Request for Bids for the 2025 Cleaning & Restoration of Sedimentation Pond No. 4

Posted: March 7, 2025

This Addendum No. 1 shall be considered part of the RFB for the 2025 Cleaning & Restoration of Sedimentation Pond No. 4 and is intended to correct, change, and/or add to the documents as described below. Please make sure to complete the Addenda Acknowledgement form included in the *Required Documents*.

SITE PLAN
 2025 CLEANING AND RESTORATION OF SEDIMENTATION POND
 FRANKLIN COUNTY SANITARY LANDFILL
 GROVE CITY, OHIO

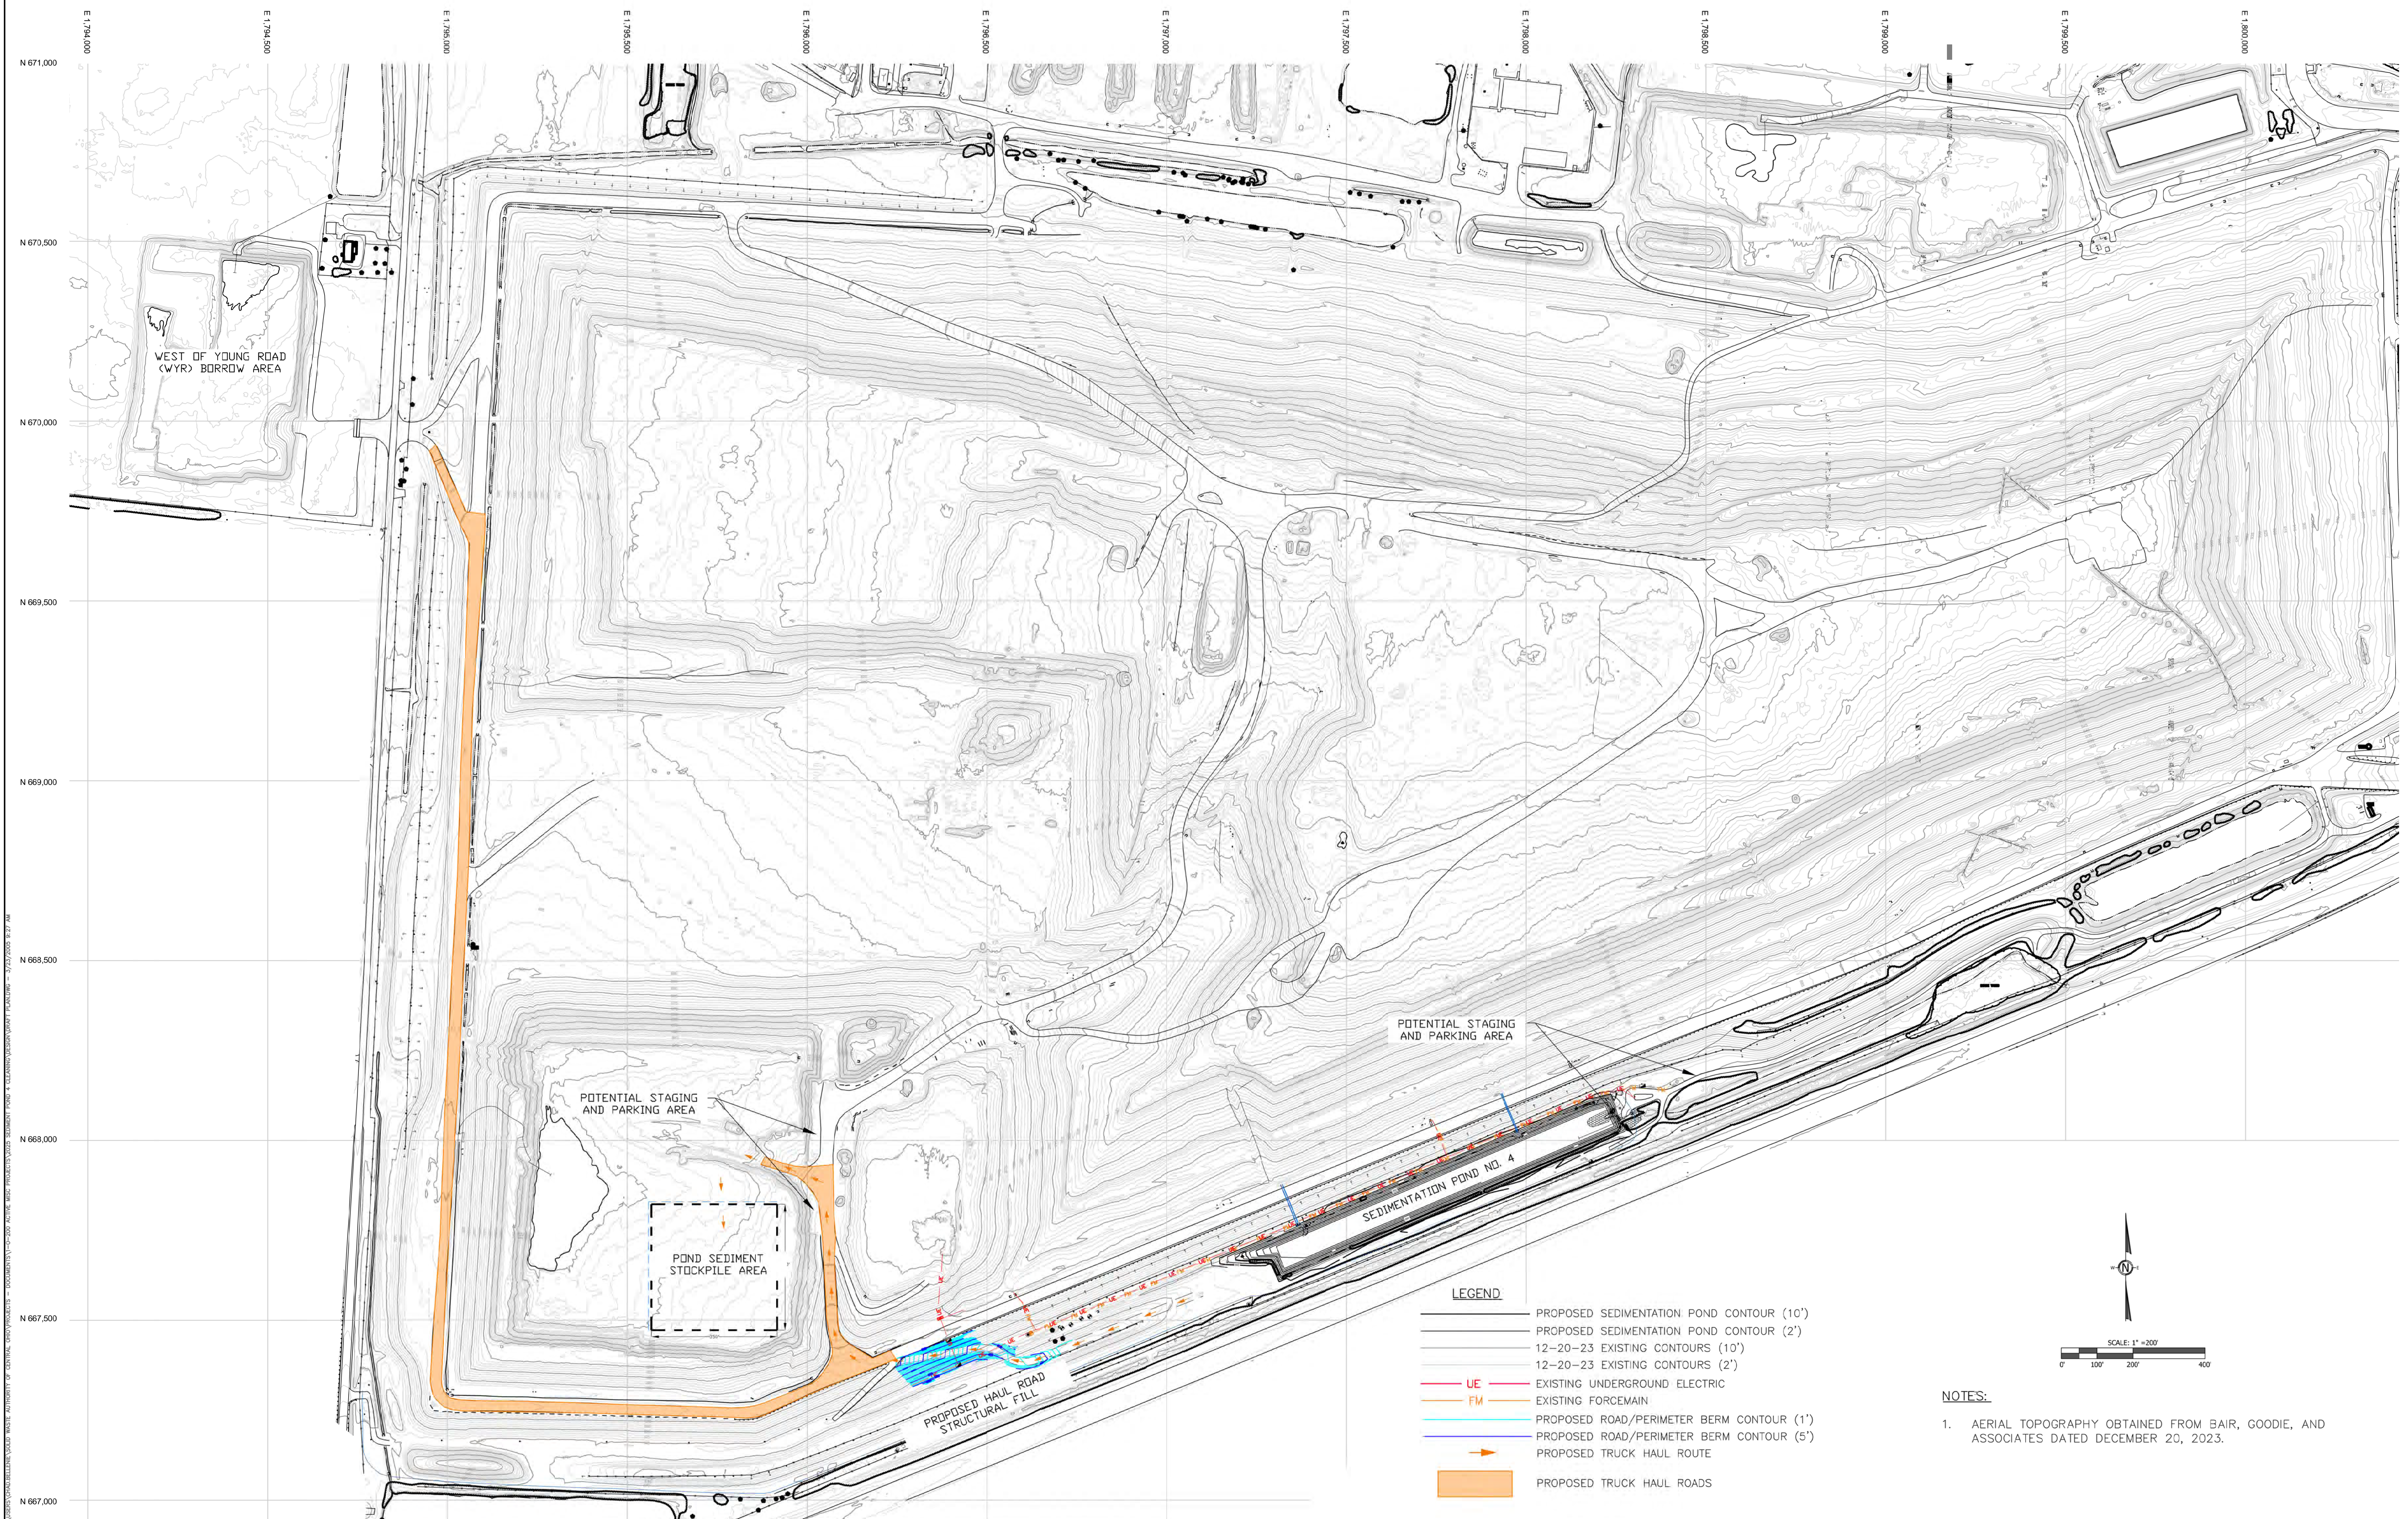
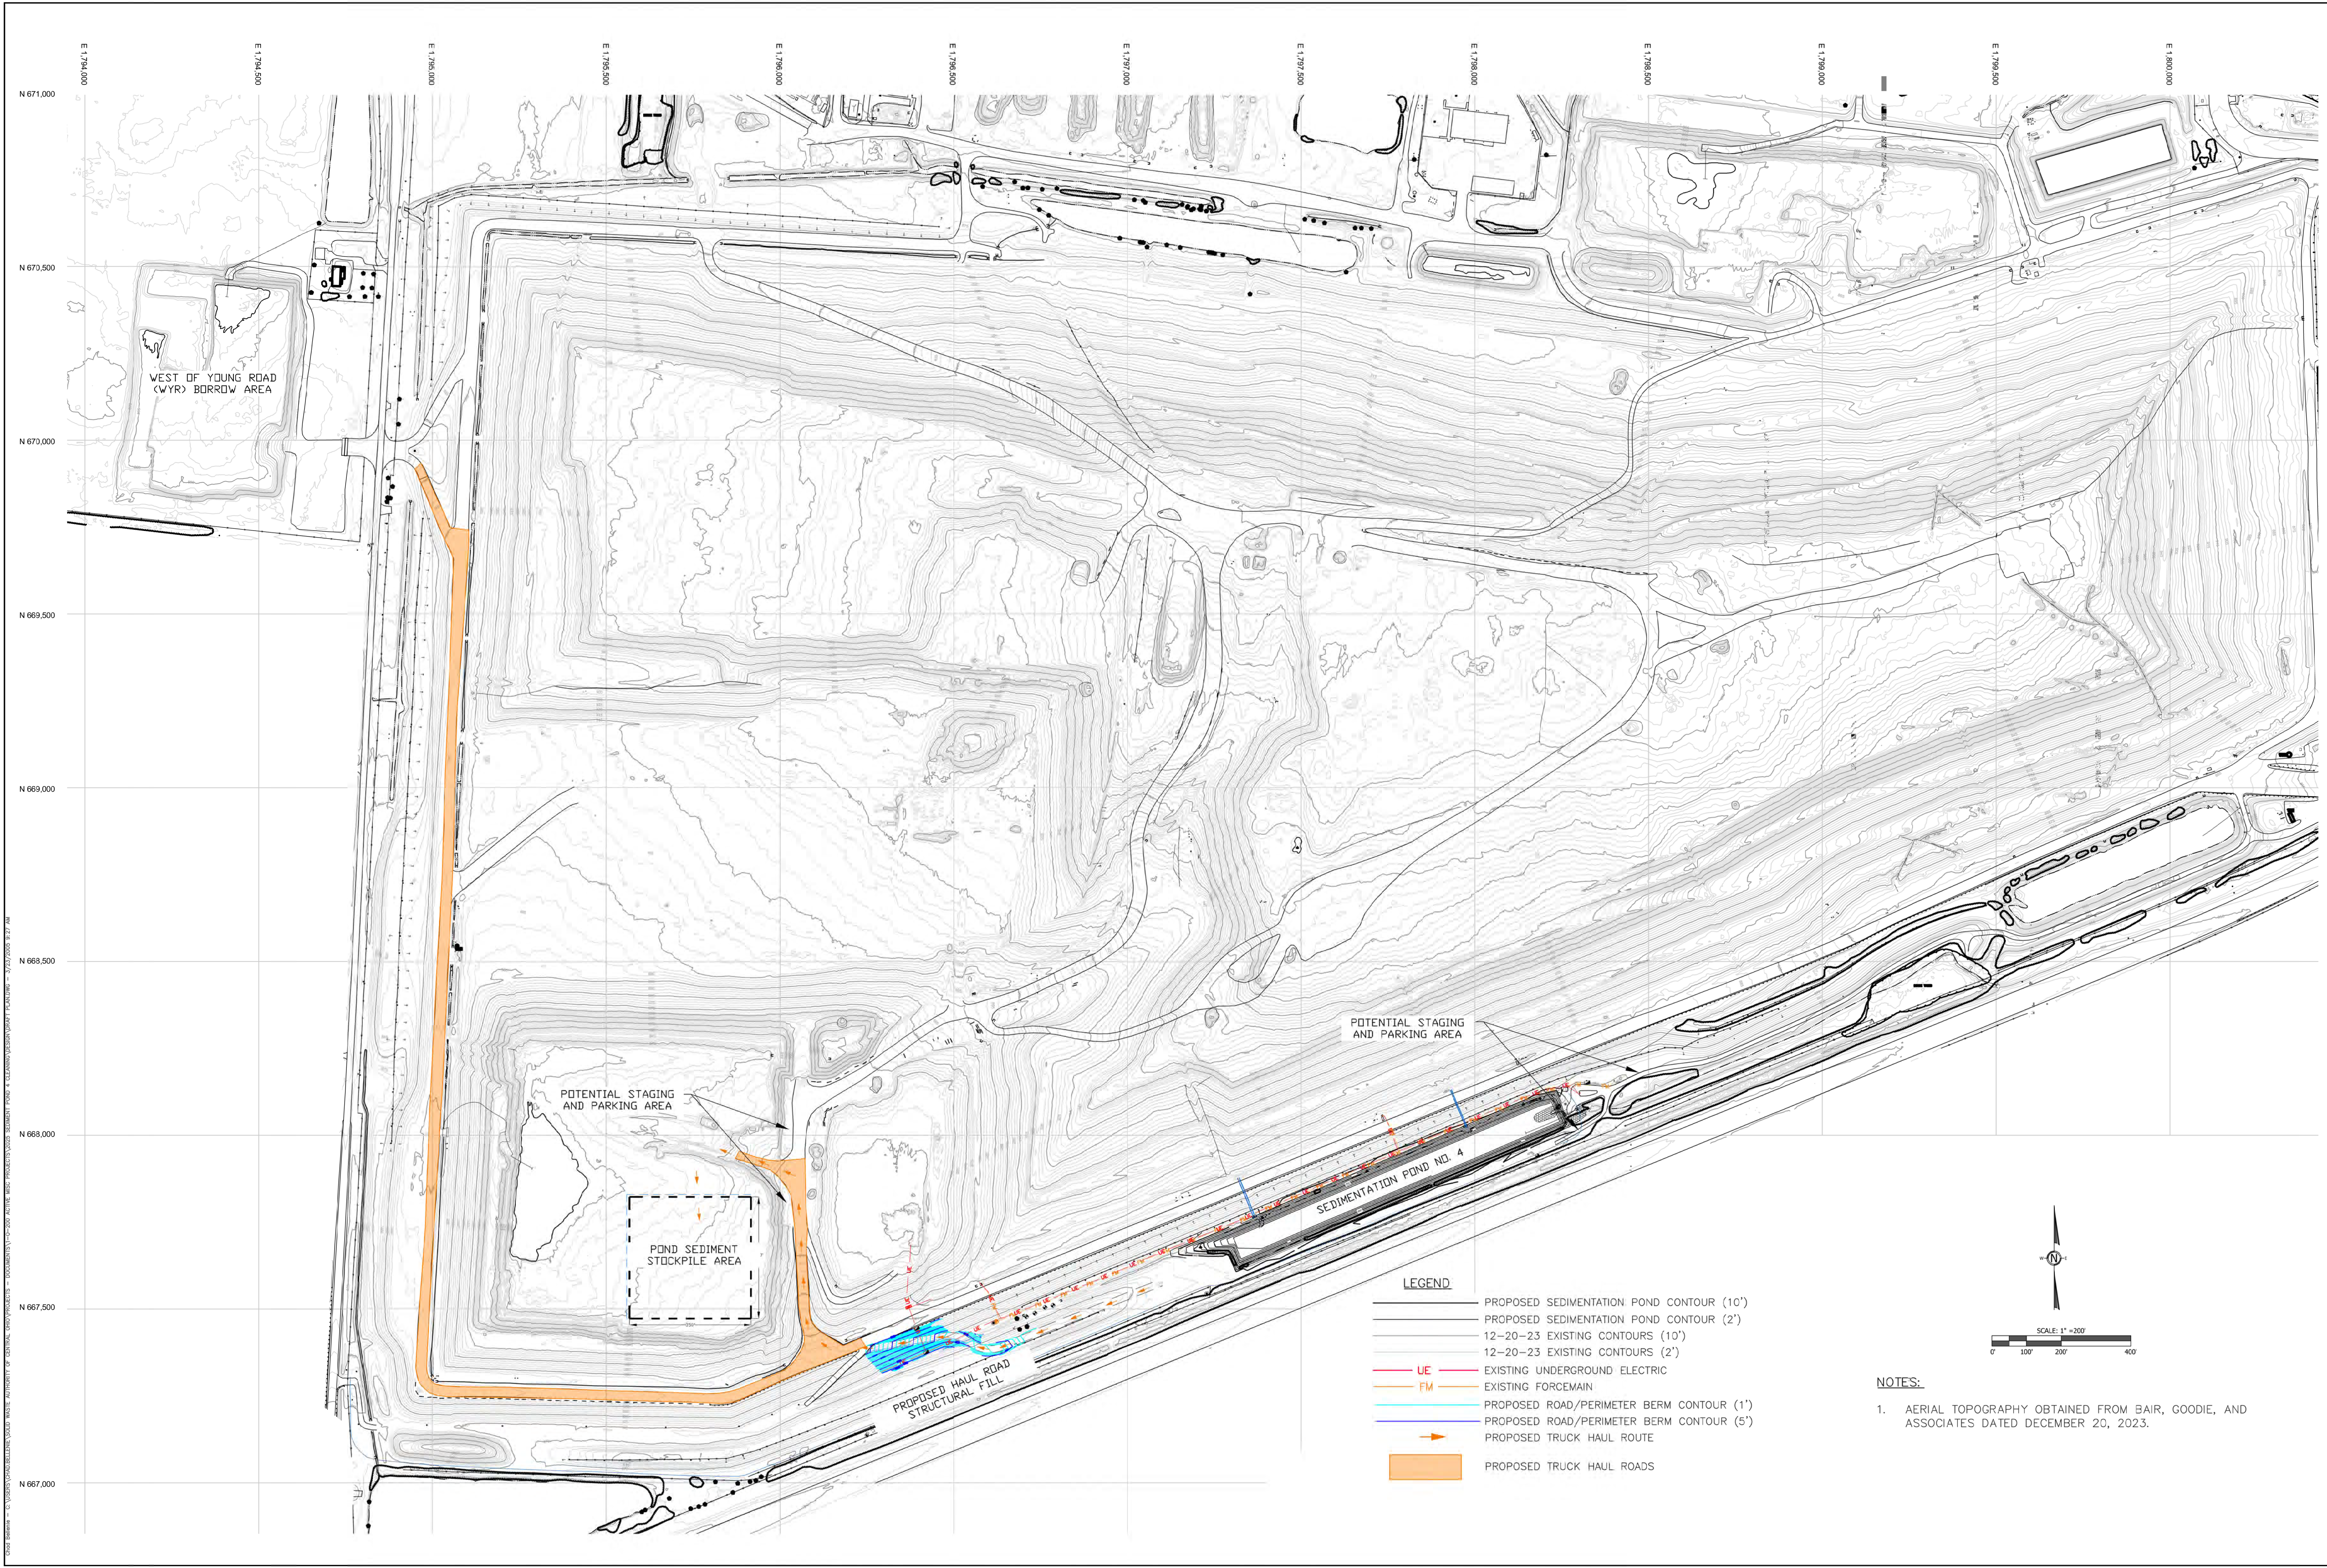
b) *In this item it also states that “surface preparation of staging and parking areas will be apart of this item”. Could you please indicate where we are able to do so in relation to the location of sediment pond 4?*

Question #3: *Item 2, this item states that the borrow material need to make fills for the haul road is obtained from the “West of Young Road borrow area”. Could you please provide an address where this borrow area is?*

Question #4: *Item 6, could you please indicate on the plans where this restoration is taking place?*

Question #11: *Where is the soil borrow source for the sediment storage berm? Can it come from the overburden soil in the future cell area or the site borrow location?*

Answer: The staging and parking locations will be determined during the preconstruction meeting based on the number of vehicles/equipment required for the Project. The staging and parking location will be as close as possible to Sedimentation Pond 4. Several potential locations are shown on the Site Plan, Sheet 4, and is attached to this Addendum No. 1.

Answer: The West of Young Road (WYR) borrow area is shown on the Site Plan.

Answer: Item 6 shall be used to repair the haul roads used during this Project. The proposed roads are shown in orange on the Site Plan.

Answer: The West of Young Road (WYR) borrow area will be used for material to construct the sediment storage berm in Item 13. Sheet 4 is included in this addendum and shows the location of the borrow source in relation to the work area.
